Lindsay 2017 Developments Inc. / Sugarwood

Lot/Unit: 12 Phase/Building: 1 Model/Floor Plan: Catchacoma Lake (4205) Elev A 4Bed
2.5Bath

SCHEDULE "B-1"
Floor Plan

Sketch #1

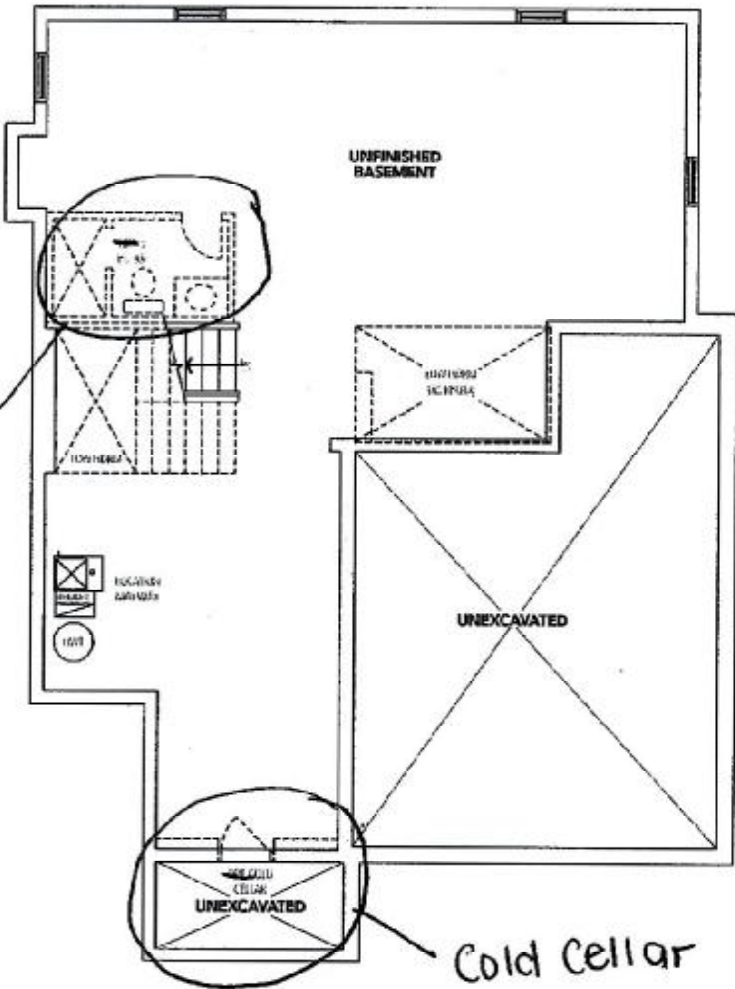
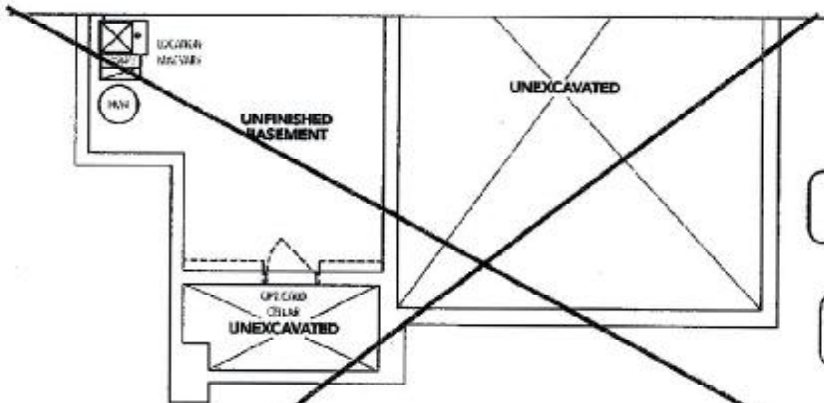
Inv.5830	1 - To supply and install the optional cold cellar in the basement.. see sketch #1	
Line 74121	Note: THIS UPGRADE IS TO BE COMPLETED BY THE CONCRETE AND DRAIN COMPANY	
12Sep22 / 12Sep22

Inv.5830	1 - To increase the height of the toe tester in the master ensuite shower to approx. 20" up from unfinished floor in lieu of the standard height..	
Line 74122	Note:	
12Sep22 / 12Sep22		
Inv.5830	1 - To supply and install the 3-piece rough-in in the basement.. see sketch #1	
Line 74120	Note:	
12Sep22 / 12Sep22

Optional 3-pc Rough-in
